# Intel<sup>®</sup> Celeron<sup>®</sup> Processor Specification Update

Release Date: May 2007

Document Number: 243748-050

Figure 1 Celeron® on 0.13 Micron Processor 256K Platforms Workaround

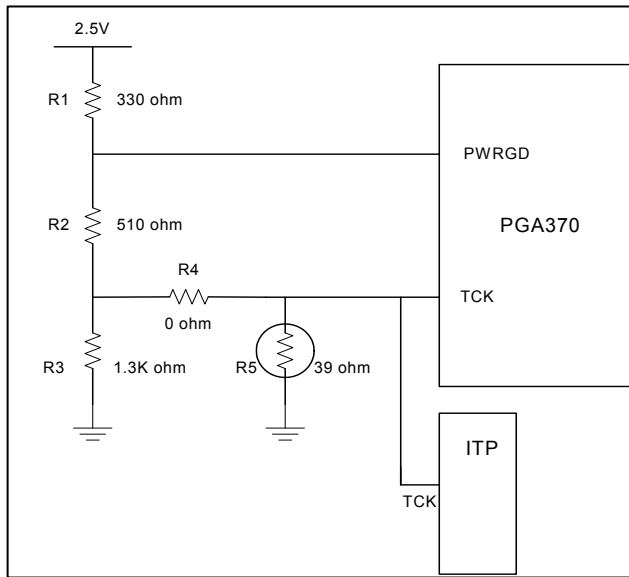
**Workaround:** To prevent the risk of power-on boot failures or catastrophic thermal failures, a platform workaround is required. The system must provide a rising edge on the TCK signal during the power-on sequence that meets all of the following requirements:

Please note, the example workaround circuits attached require circuit modification for ITP tools to function correctly. These modifications must remove the workaround circuitry from the platform and may cause systems to fail to boot. Review the accompanying notes with each workaround for ITP modification details. If the system fails to boot when using ITP, issuing the ITP 'Reset Target' command on failing systems will reset the system and provide a sufficient rising edge on the TCK pin to ensure proper system boot.

In addition, the example workaround circuits shown do not support production motherboard test methodologies that require the use of the processor JTAG/TAP port. Alternative workaround solutions must be found if such test capability is required.
